REPORT TO CITY COUNCIL

Council Meeting of: July 7, 2021

Request for direction on possible changes to the City of Madera Typical Street Cross Sections

COLLECTOR STREET
 WITH
 TWO-WAY LEFT TURN LANE

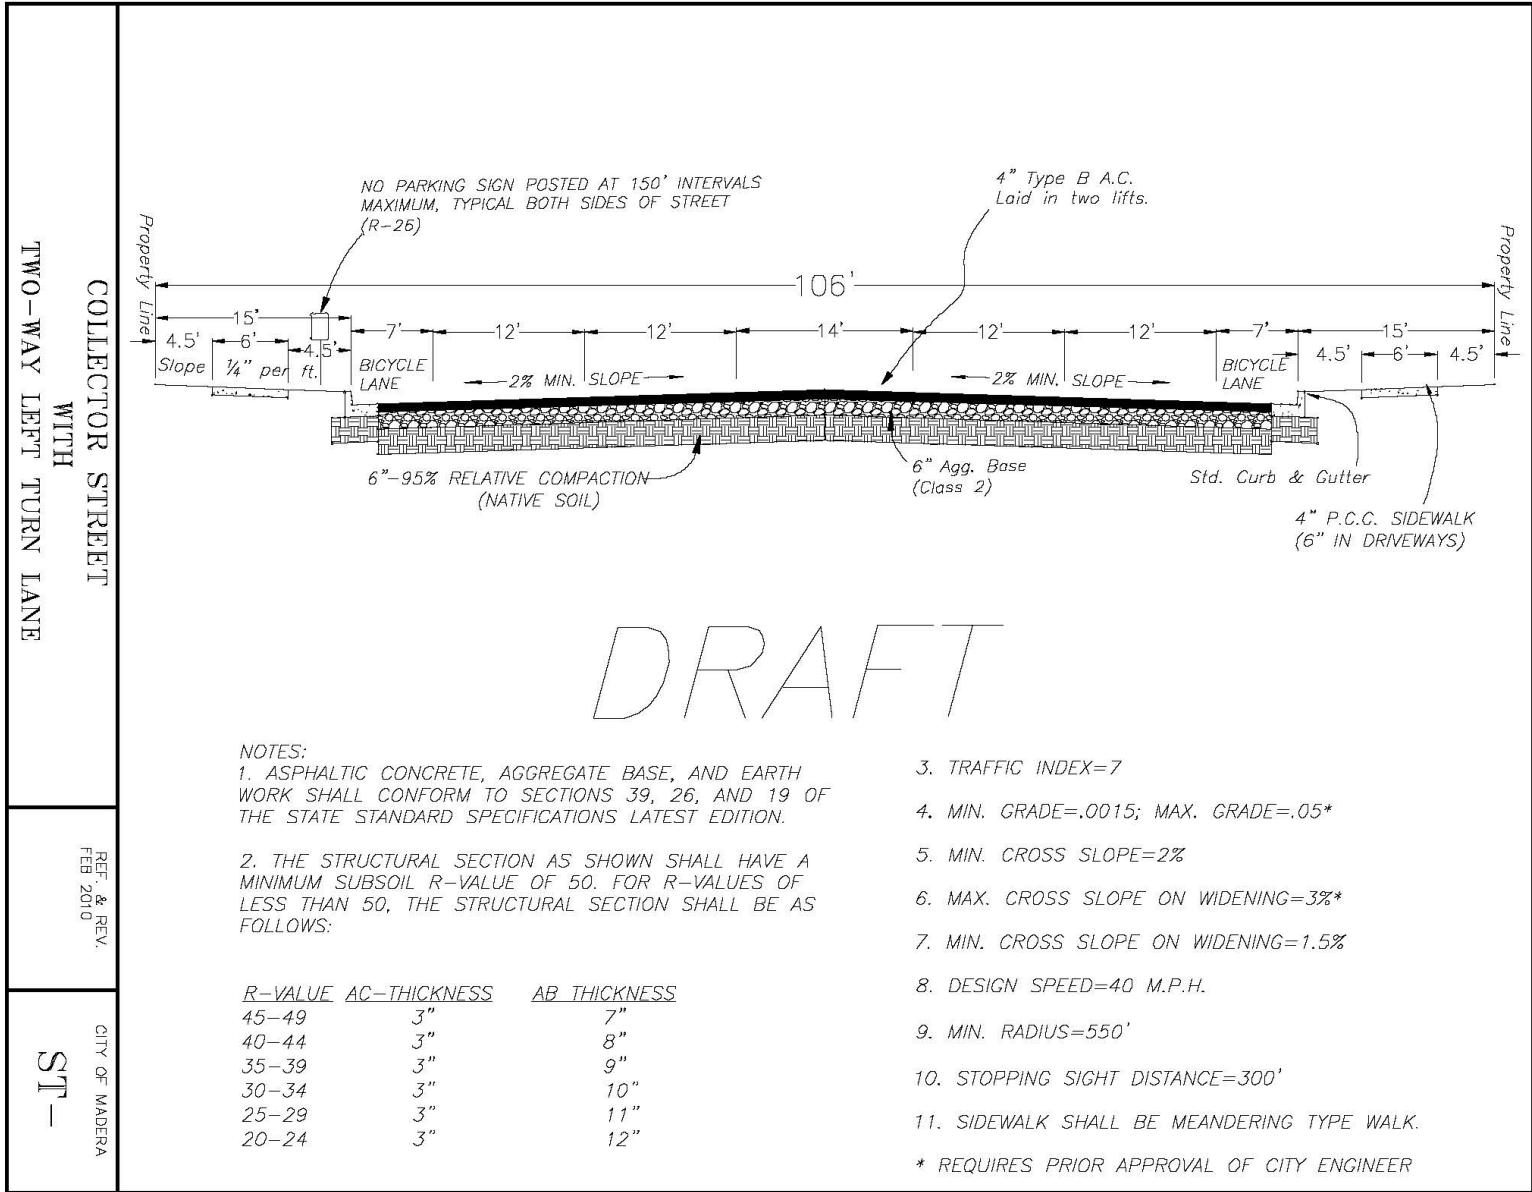
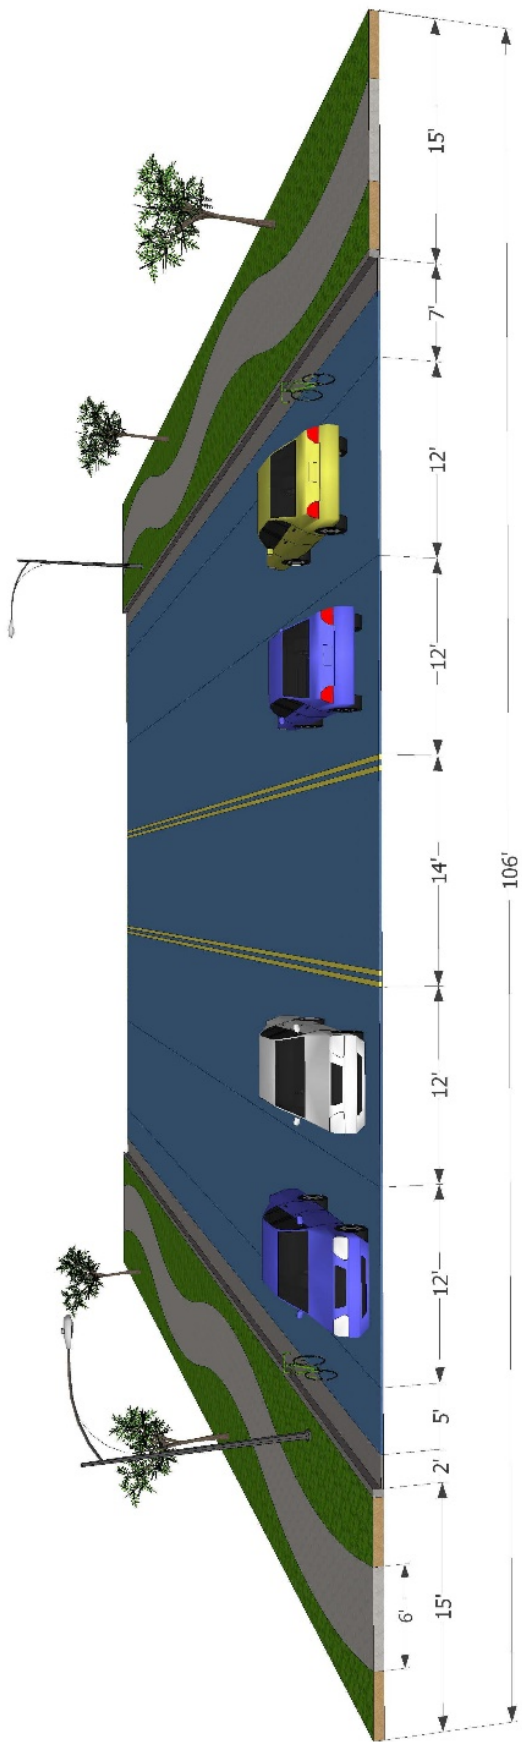
- Dedicated Bike Lanes – Known as a Class II Bike Lane, a dedicated “in-street” 5-foot bike lane is provided within both the collector and arterial road cross sections.

- Sidewalk - Sidewalk width is shown to be increase from 5 to 6 feet. At 5 feet, many people find it difficult to walk in pairs or pass other pedestrians walking in the opposite direction without stepping off the sidewalk. At 5 feet, the sidewalk is perhaps more utilitarian than user-friendly as is the goal of the Vision.

- Aesthetics – The current park strip width is 10-feet in width for both collectors and arterials. The wider width was originally proposed because it was felt it would more fully achieve the intent of the Vision and is specifically mentioned in the Vision. As a result, the landscape area within the park strip is proposed to increase from 4.5 feet to 8.5 feet on collectors and 4.5 feet to 14 feet on arterials. This change allows for a more pronounced meandering sidewalk and additional park strip area that will assists in buffering the street from the adjoining uses. Given the drought that was active when these standards were first considered in 2015, the current drought and the changing views of what constitutes an acceptable landscape scheme, park strip features will likely need to include a combination of hardscape and drought tolerant landscaping. While the densely landscaped green corridors contemplated just a few years ago is not likely to reemerge in the near term, a wider park strip and meandering sidewalk can assist in creating a safer and more visually inviting pedestrian environment called for by the Vision and the General Plan.

ARTERIAL STREET 4 LANE

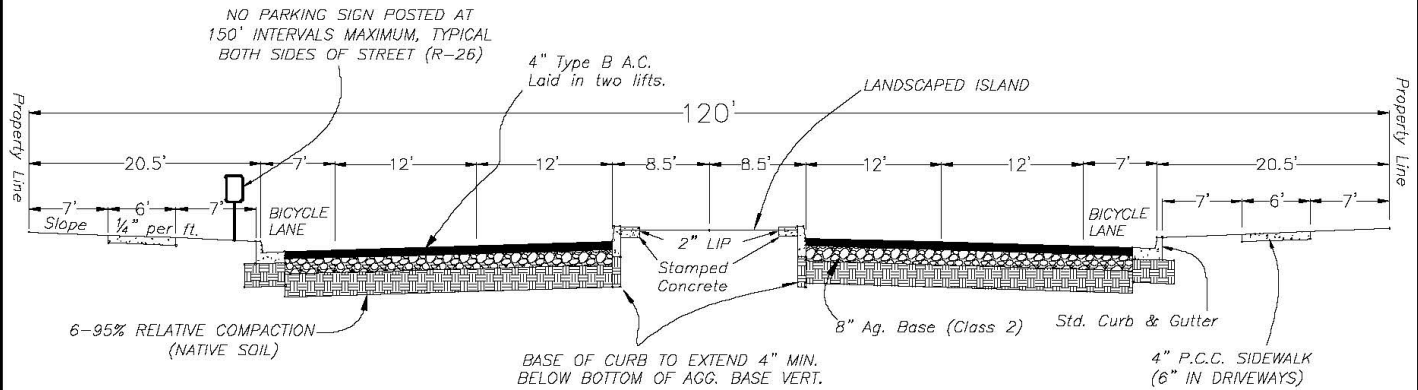
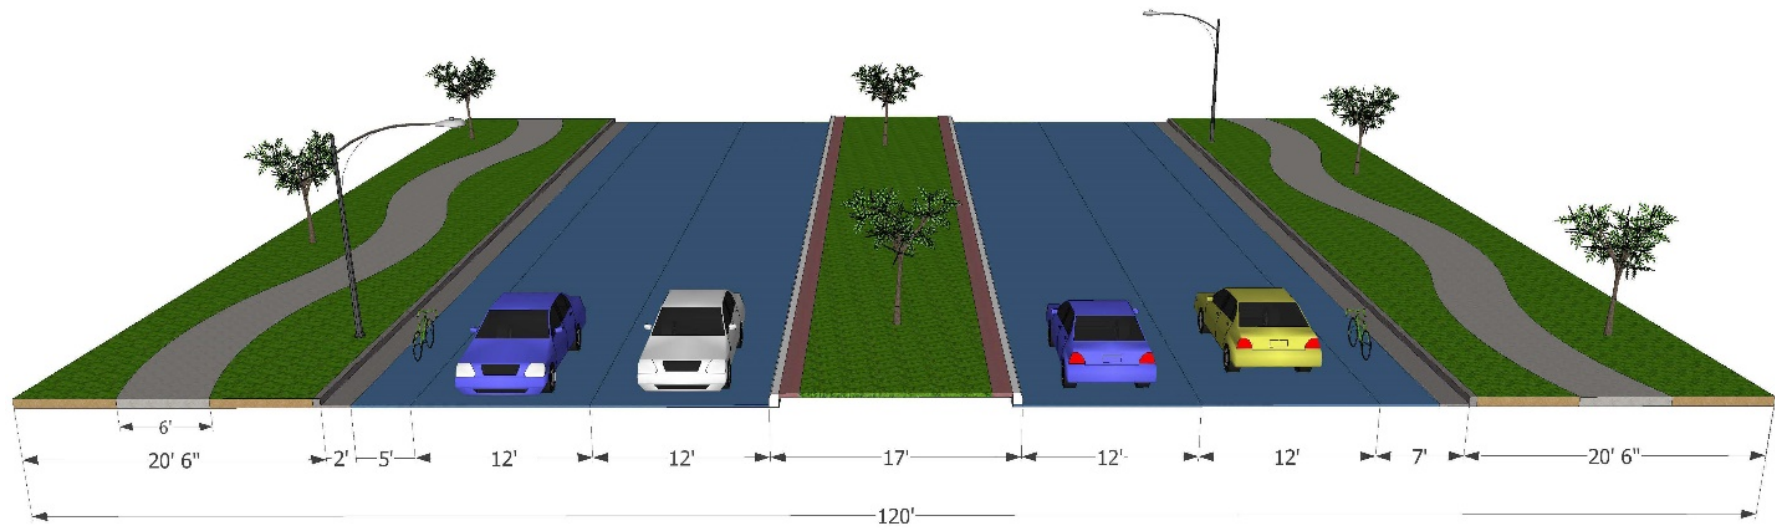
- Safety – The arterial street cross section proposes an increase in the width of the median on arterials from 16 to 17 feet. This change is proposed to provide a 6-foot pedestrian refuge at pedestrian crossings, a standard that Caltrans required on designs at the time the standards were presented to Council. Other organizations including FHWA and National Association of City Transportation Officials recommend larger refuge areas. As a result, left turn bays will also be reduced from a standard 12 feet to 11 feet. A 6-foot wide refuge better accommodates a bicycle and rider as well.

ARTERIAL STREET 6 LANE

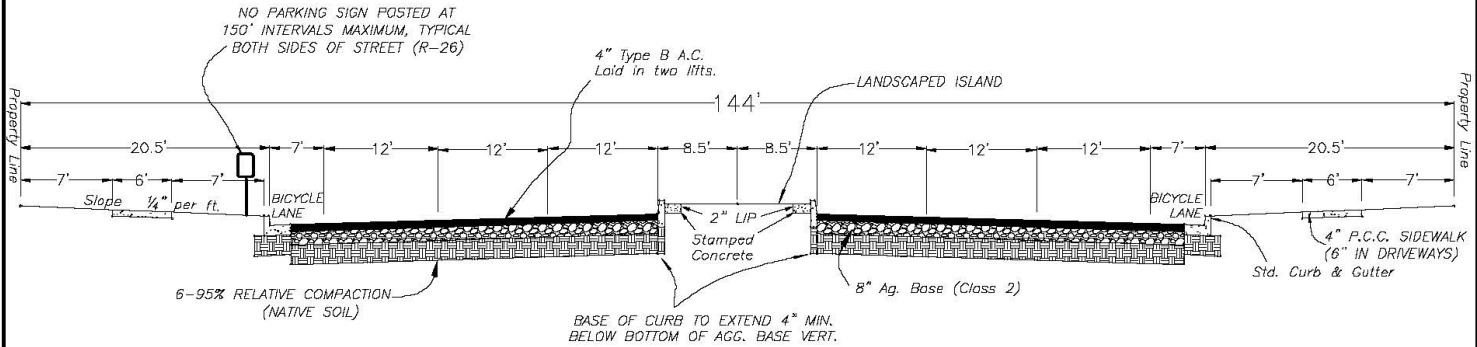
Impacts of the conceptual changes ultimately come down to two things; improvement cost and the increased use of land for larger street rights-of-way that would typically be used by the adjacent property owner for development. The arterial street cross section increases the right-of-way requirement from 100 feet to 120 feet (144 feet for 6 lanes) while the collector cross section increases from 80 feet to 106 feet. Costs associated with these increases come from both the increased right-of-way dedication and improvements to be constructed within this additional area. The following table provides a comparison of existing City standards to the conceptual standards.
